Design Advisory Board

1.1. Session I - 3:00 pm - 3:30 pm
ZP-26-105; 757 South Prospect St (RL, Ward 6) Jane Alsofrom
Proposed exterior renovations included reducing size of porches, new patio, new siding, two new windows, two new wooden doors, new sliding glass door, and garage door. (Project Manager, Kirk Dressing)

TO: Design Advisory Board
FROM: Kirk Dressing, Associate Planner
DATE: May 26, 2026
RE: ZP-26-105; 757 South Prospect Street

Request: Proposed exterior renovations including reducing size of porches, new entryway, new patio, new siding, two new windows, two new wooden doors, new sliding glass door, and garage door.

1 **FIRST FLOOR PLAN**
SCALE: 1" = 20'

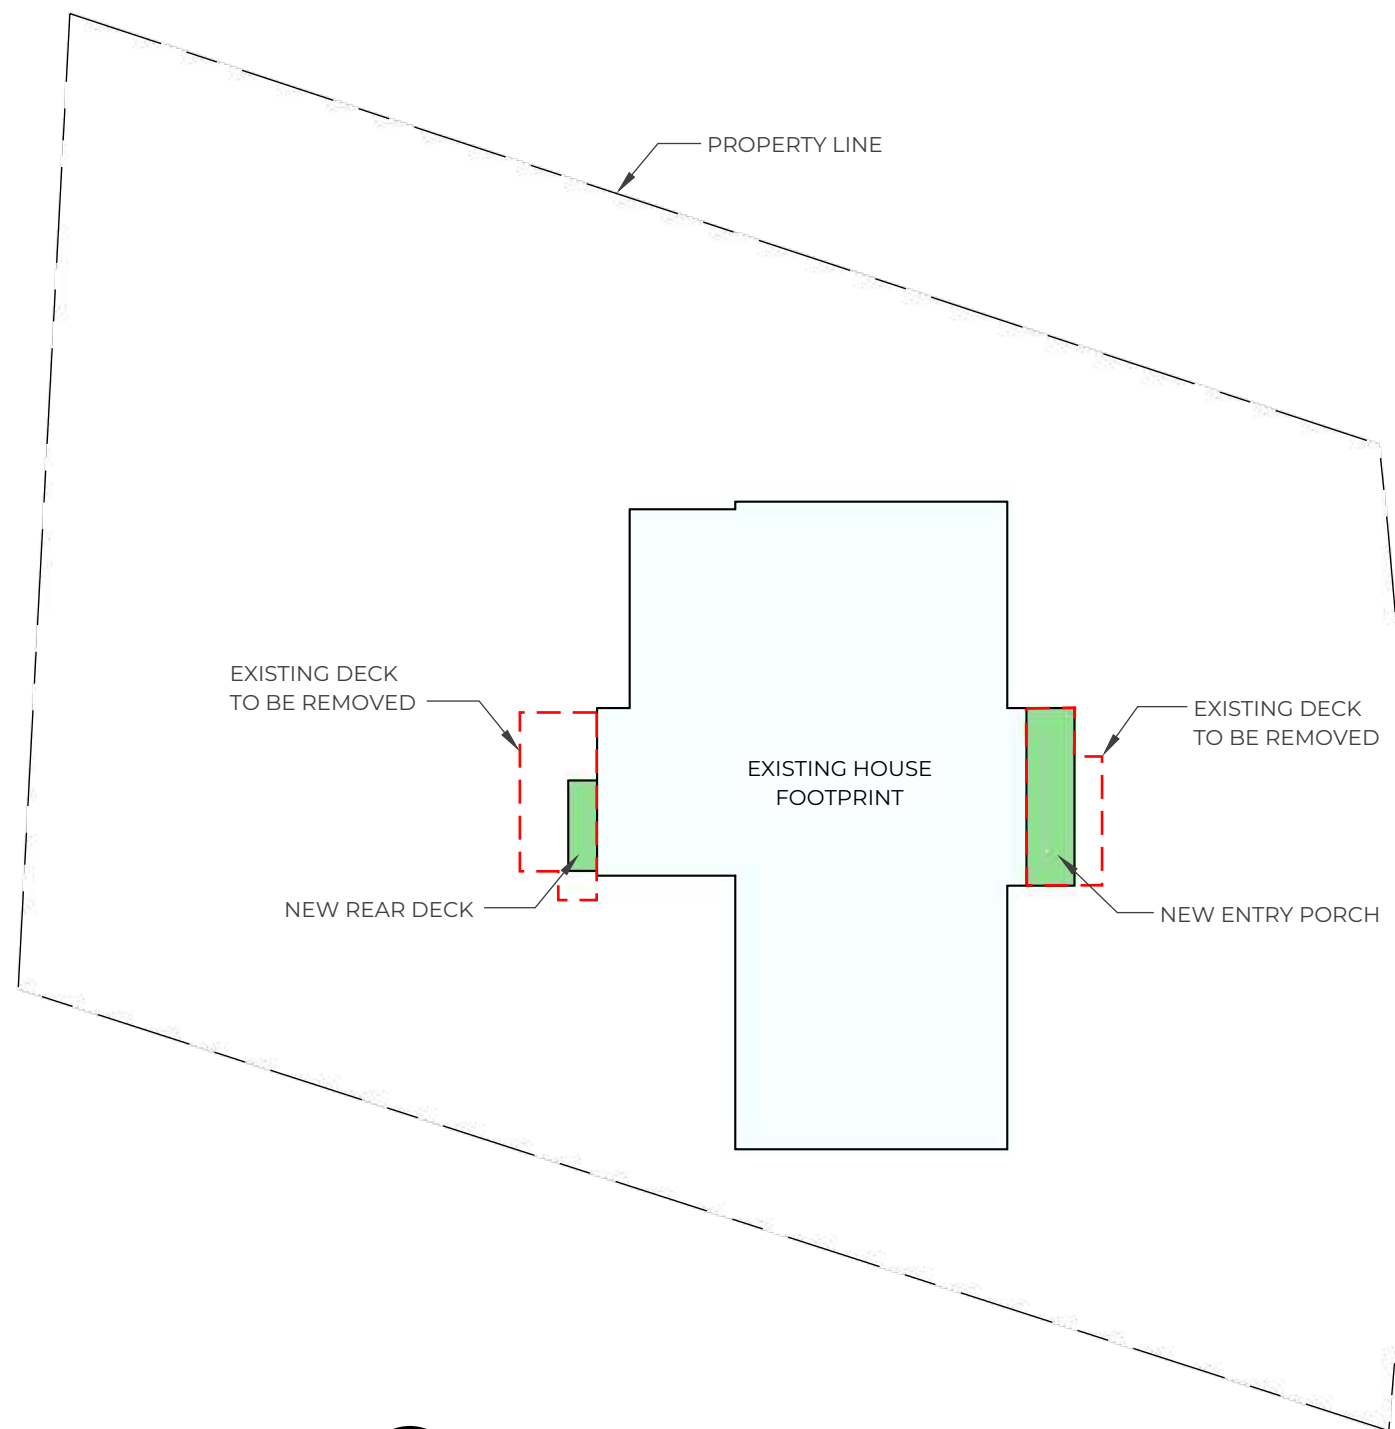
Proposed stormwater infiltration areas are identified on the proposed plan. An Erosion Prevention and Sediment Control plan has not been submitted, but one is required.

The submitted site plan shows the proposed show there will be a walkway extension to provide a clear path from the driveway to the front entrance.
